Officially Released to the LBNL Document Control Center
Released: January 23rd, 2006 DCC Auth Key: 842OOQBV04
Downloaded by: Phil Pfund at January 24, 2006 06:02:36

LHC IR FEEDBOX
ELECTRICAL
DFBXA (IR1 L) WIRING DIAGRAMS

DWG. NO. 25I6136 | REV. D | SIZE | REV. SYM.

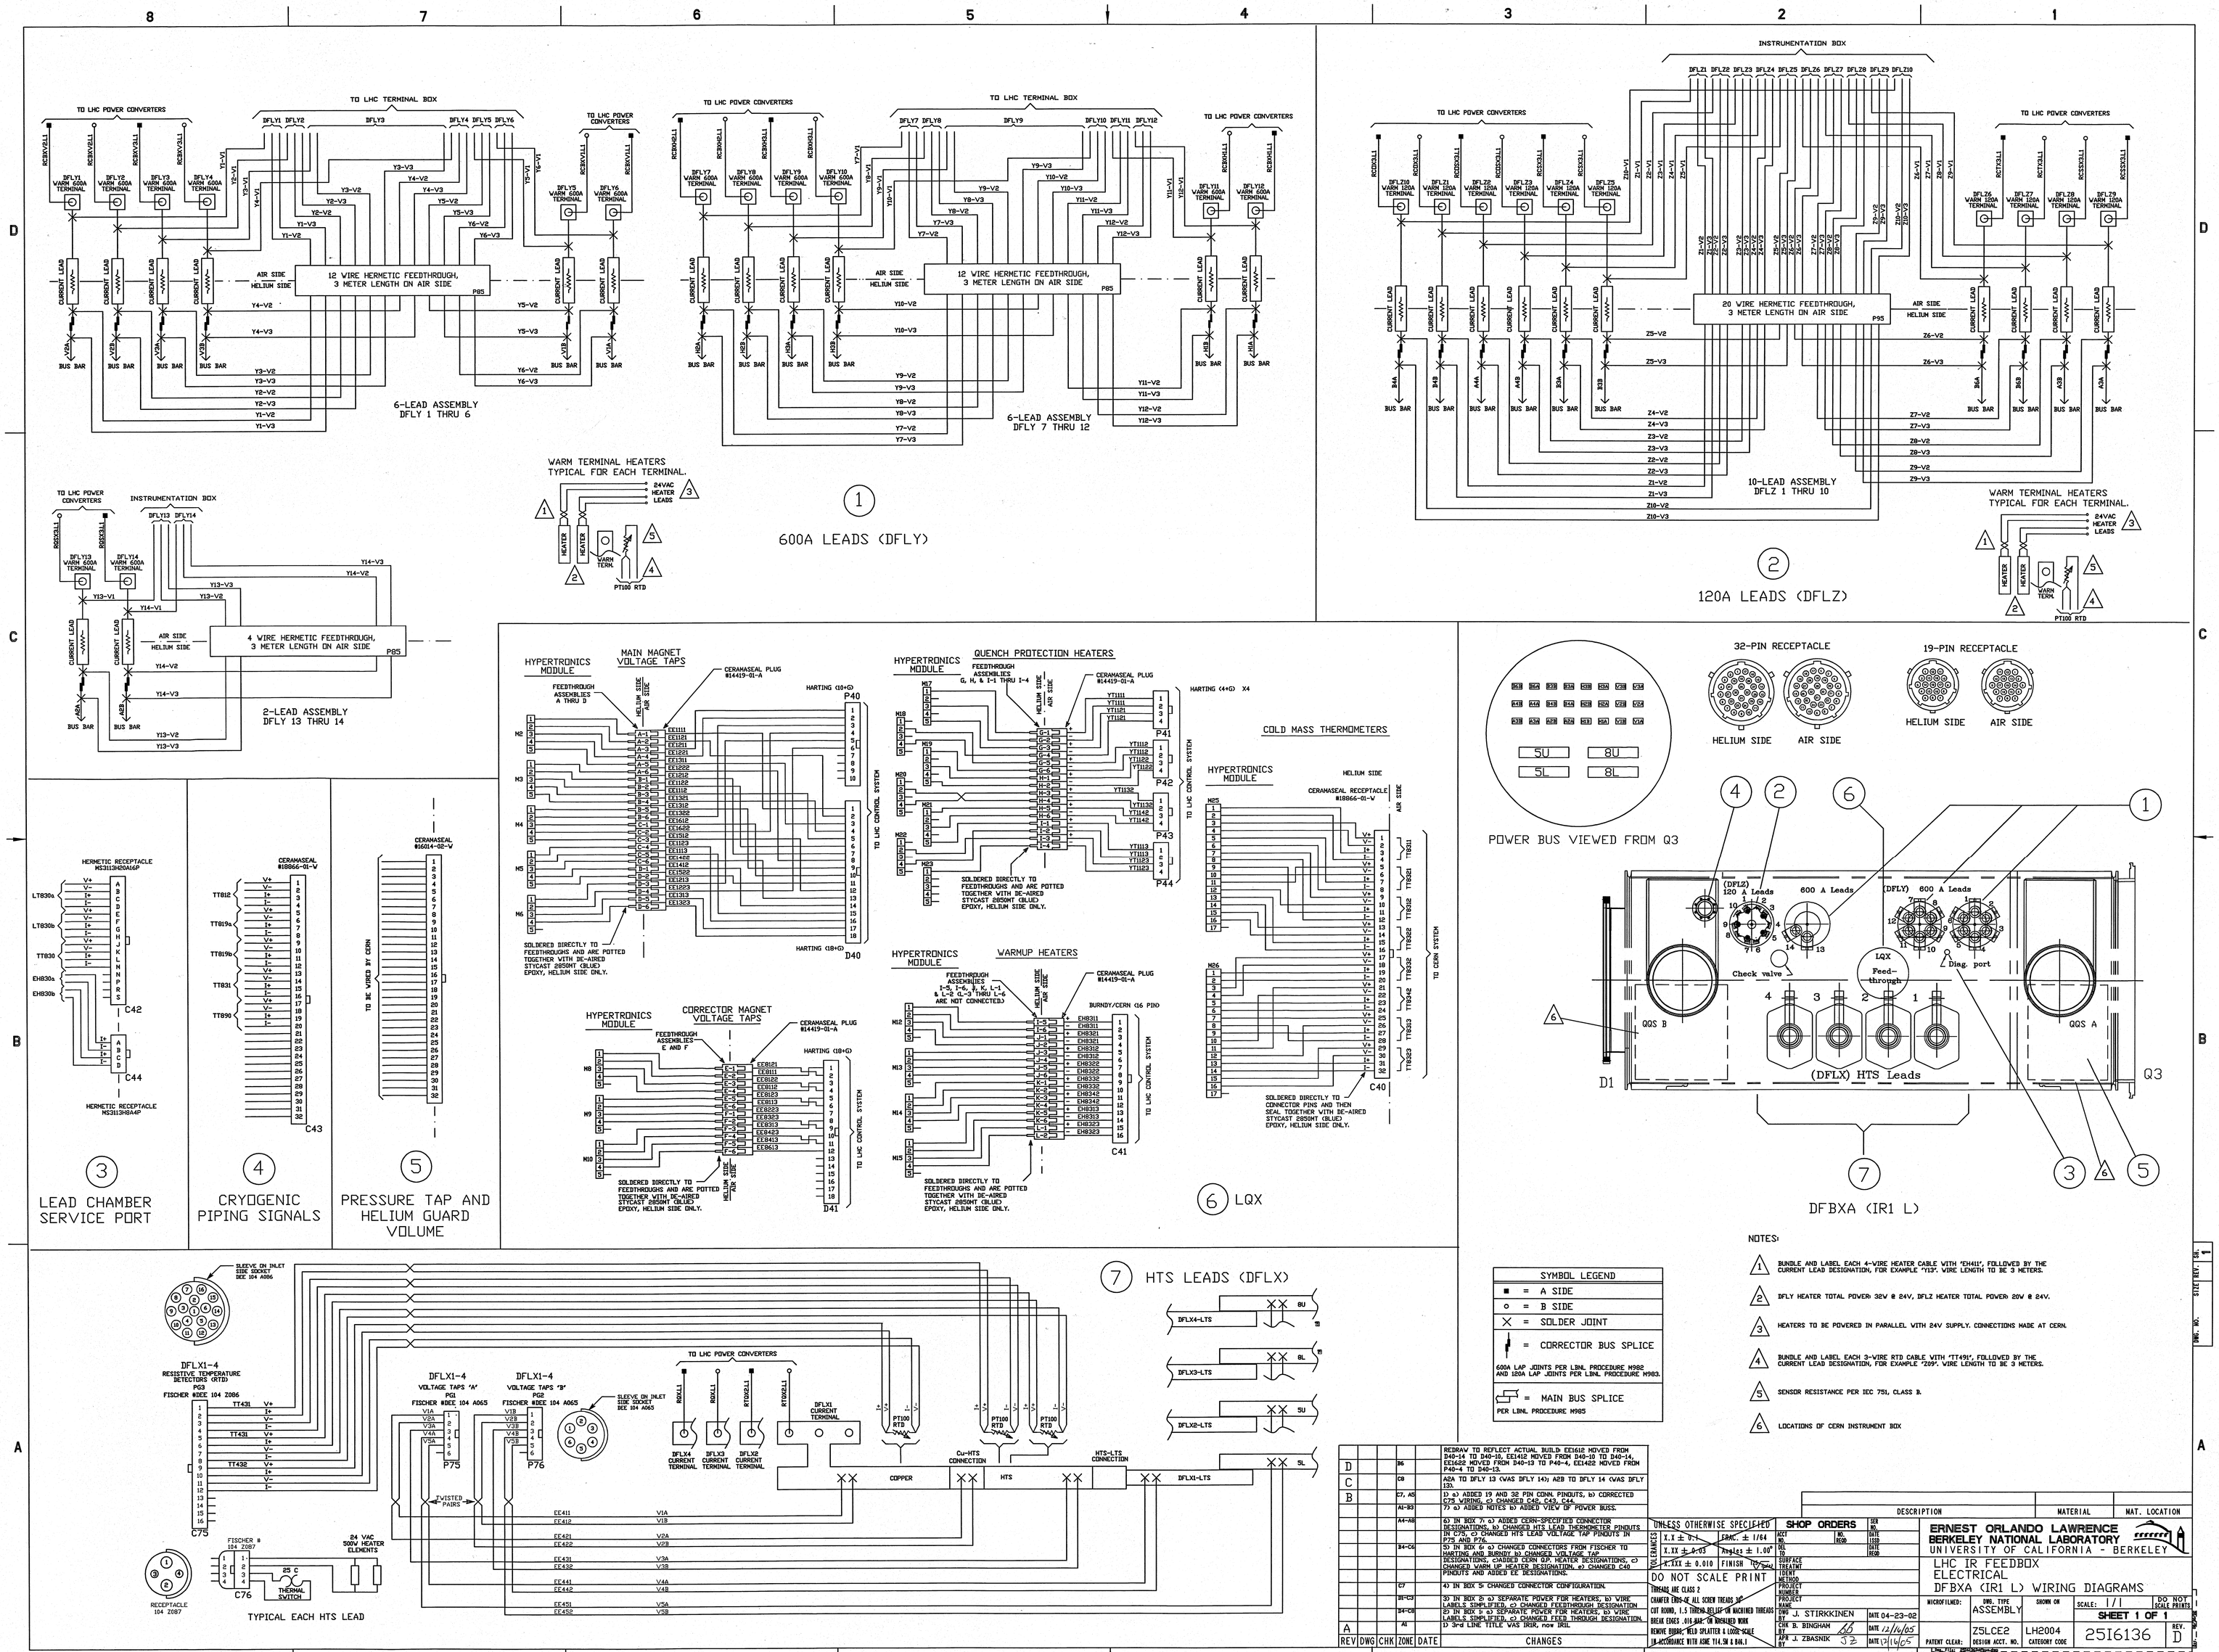
REV	DWG	CHK	ZONE	DATE	CHANGES
D			B6		REDRAW TO REFLECT ACTUAL BUILD: EE1612 MOVED FROM D40-14 TO D40-10, EE1412 MOVED FROM D40-10 TO D40-14, EE1622 MOVED FROM D40-13 TO P40-4, EE1422 MOVED FROM P40-4 TO D40-13.
C			C8		A2B TO DFLY 13 (WAS DFLY 14); A2B TO DFLY 14 (WAS DFLY 13).
B			C7, A5		1) a) ADDED 19 AND 32 PIN CONN. PINOUTS, b) CORRECTED S75 WIRING, c) CHANGED C42, C43, C44. 7) a) ADDED NOTES b) ADDED VIEW OF POWER BUSS.
			A1-B3		
			A4-A8		6) IN BOX 7: a) ADDED CERN-SPECIFIED CONNECTOR DESIGNATIONS, b) CHANGED HTS LEAD THERMOMETER PINOUTS IN C75, c) CHANGED HTS LEAD VOLTAGE TAP PINOUTS IN P75 AND P76.
			B4-C4		5) IN BOX 6: a) CHANGED CONNECTORS FROM FISCHER TO HARTING AND BURNDY b) CHANGED VOLTAGE TAP DESIGNATIONS, c)ADDED CERN QP. HEATER DESIGNATIONS, c) CHANGED WARM UP HEATER DESIGNATION. e) CHANGED C40 PINOUTS AND ADDED EE DESIGNATIONS.
			C7		4) IN BOX 5: CHANGED CONNECTOR CONFIGURATION.

B1-C3		3) IN BOX 3: a) SEPARATE POWER FOR HEATERS, b) WIRE LABELS SIMPLIFIED, c) CHANGED FEEDTHROUGH DESIGNATION
			B4-C8		2) IN BOX 1: a) SEPARATE POWER FOR HEATERS, b) WIRE LABELS SIMPLIFIED, c) CHANGED FEED THROUGH DESIGNATION.
A			A1		1) 3rd LINE TITLE WAS IR1R, now IR1L
